New York Telephone Co.

B599.081
~~Engineering Bulletin 444~~

PRIVATE BRANCH EXCHANGES—

#63 Induction Coil Telephone Set

FIGURE 1

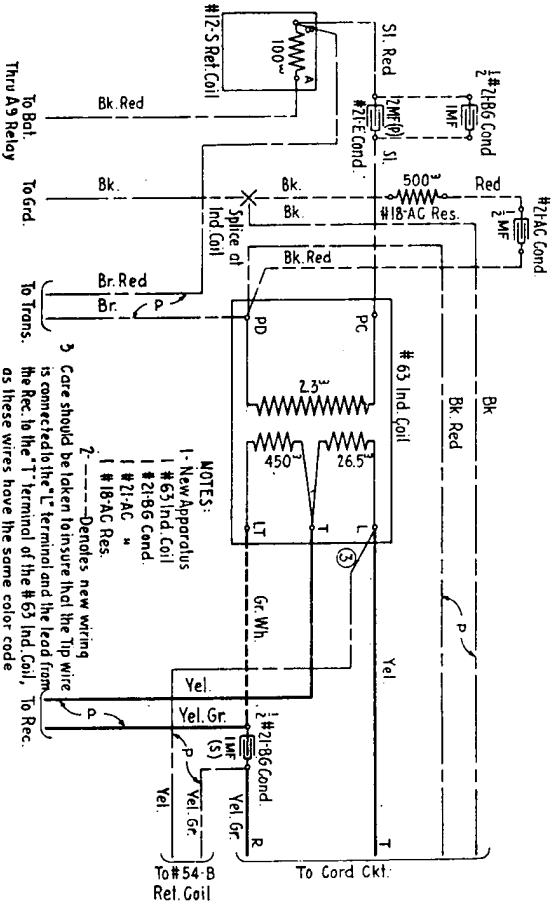
*** 550-A P. B. X. SWITCHBOARD**

Method of Rewiring Attendant's Telephone Set Circuit Using * 63 Induction Coil

FIGURE 2

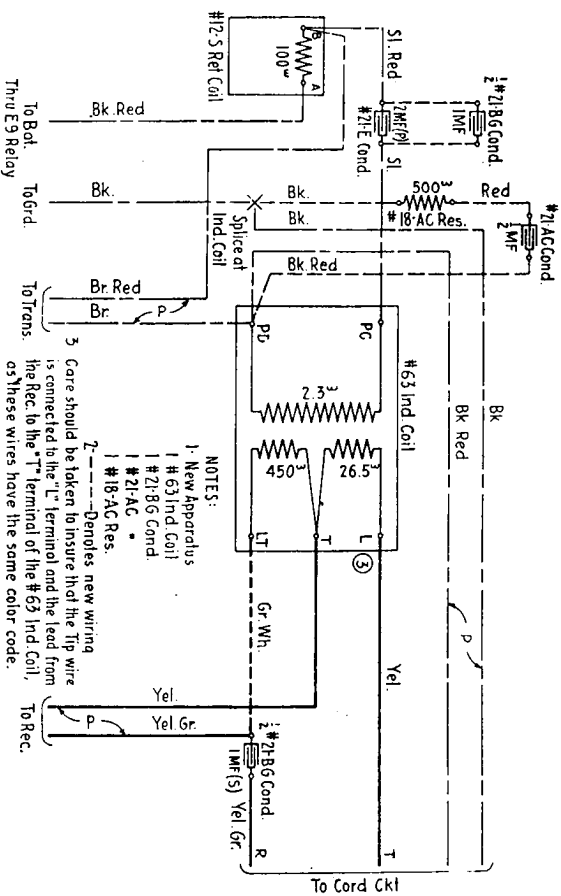
3 Care should be taken to insure that the Tip wire is connected to the "L" terminal and the lead from the Rec. to the "T" terminal of the #63 Ind. Coil, as these wires have the same color code.

- NOTES:
- 1- New Apparatus
 - 1 #63 Ind. Coil
 - 1 #21-BG Cond.
 - 1 #21-AC
 - 1 #18-AC Res.

2- --- Denotes new wiring

* 550-B P. B. X. SWITCHBOARD

Method of Rewiring Attendant's Telephone Set Circuit Using * 63 Induction Coil

FIGURE 3

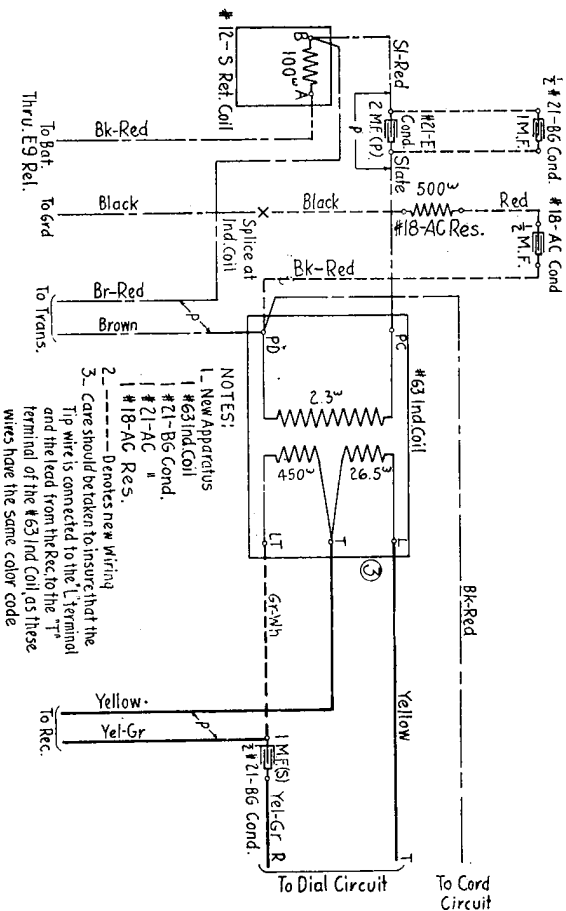
* 550-C P. B. X. SWITCHBOARD WIRED PER CIRCUIT PASTER P-162190
 Method of Rewiring Attendant's Telephone Set Circuit Using * 63 Induction Coil

FIGURE 4

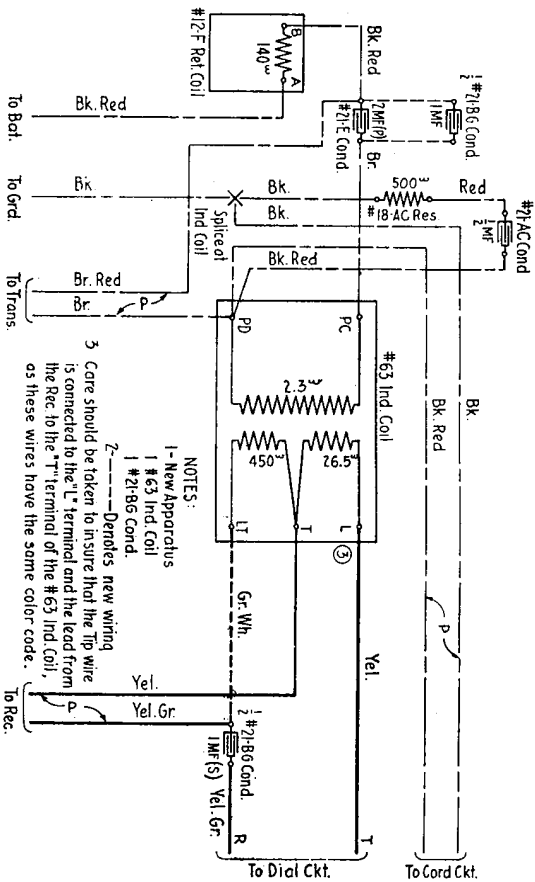
*** 550-C P. B. X. SWITCHBOARD WIRED PER CIRCUIT PASTER P-69227
Method of Rewiring Attendant's Telephone Set Circuit Using * 63 Induction Coil**

FIGURE 5

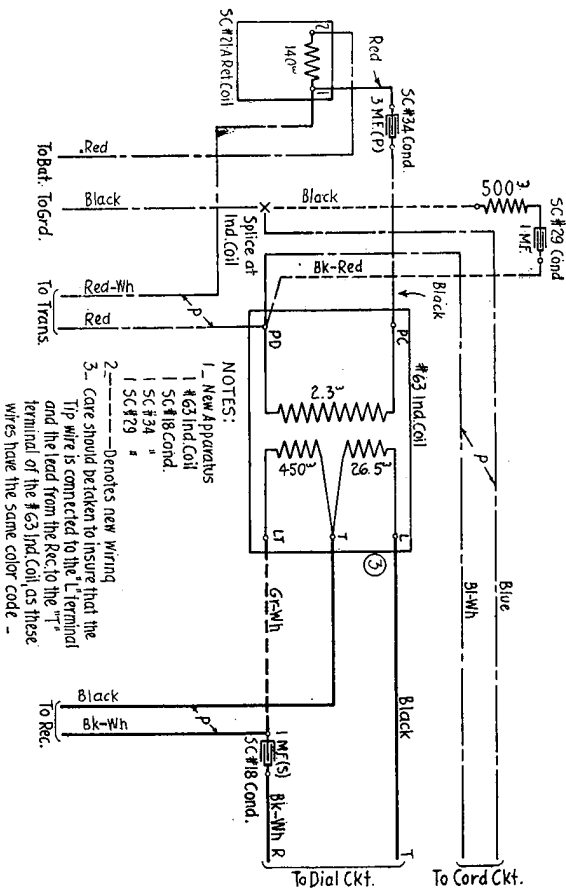
* 550-SC P. B. X. SWITCHBOARD WIRED PER CIRCUIT PASTER FORM * 948
Method of Rewiring Attendant's Telephone Set Circuit Using * 63 Induction Coil

FIGURE 6

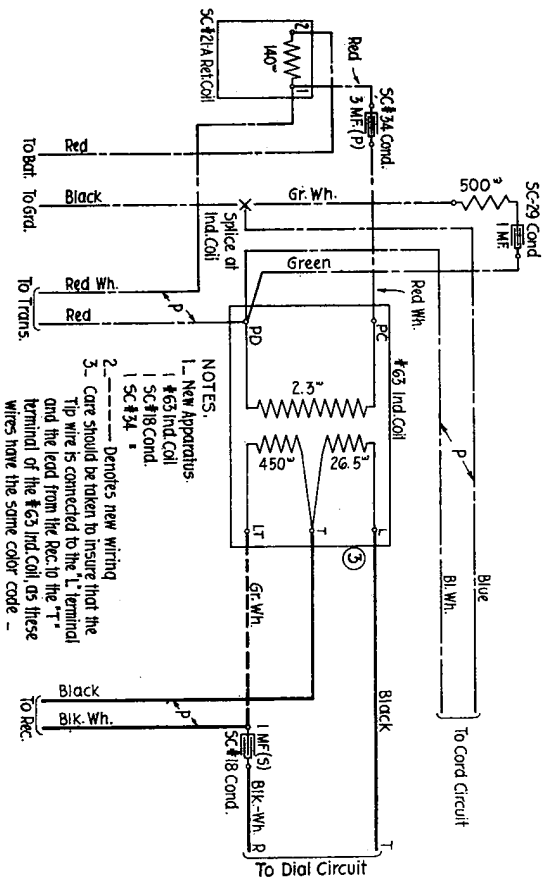
*** 550-SC P. B. X. SWITCHBOARD WIRED PER CIRCUIT PASTER FORMS * 967 and * 1078
Method of Rewiring Attendant's Telephone Set Circuit Using * 63 Induction Coil**

FIGURE 7

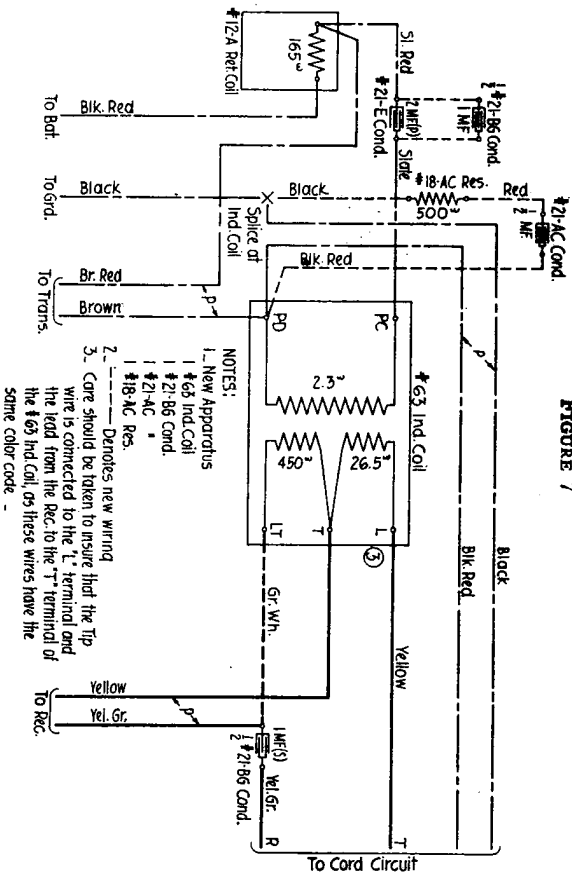
※ 600-A and 600-B P. B. X. SWITCHBOARD

Method of Rewiring Attendant's Telephone Set Circuit Using ※ 63 Induction Coil

FIGURE 8

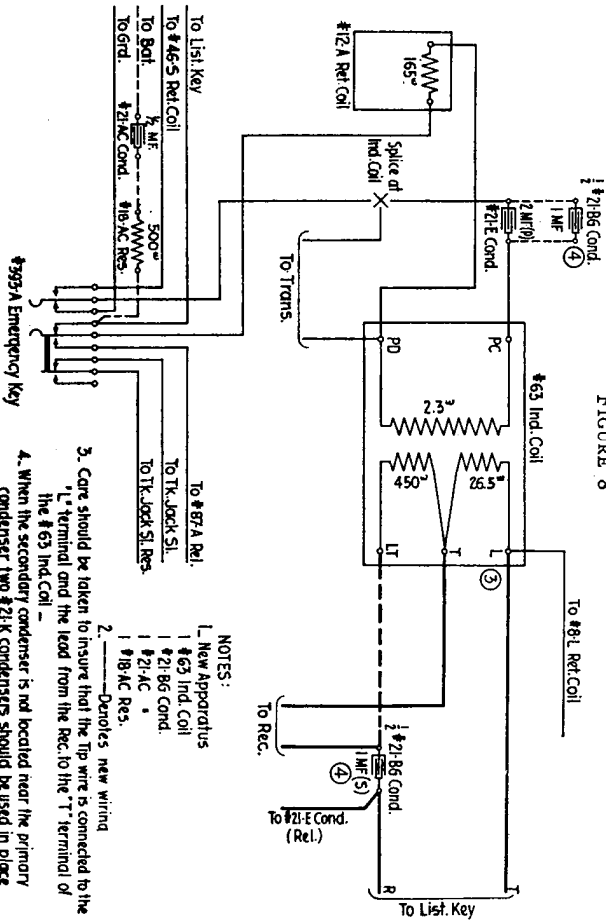
* 1 MAGNETIC SIGNAL P. B. X. SWITCHBOARD

Method of Rewiring Attendant's Telephone Set Circuit Using * 63 Induction Coil

- Denotes new wiring
- Care should be taken to insure that the Tip wire is connected to the "L" terminal and the lead from the Rec. to the "T" terminal of the #63 Ind. Coil -
- When the secondary condenser is not located near the primary condenser two #21-K condensers should be used in place of the #21-B6.
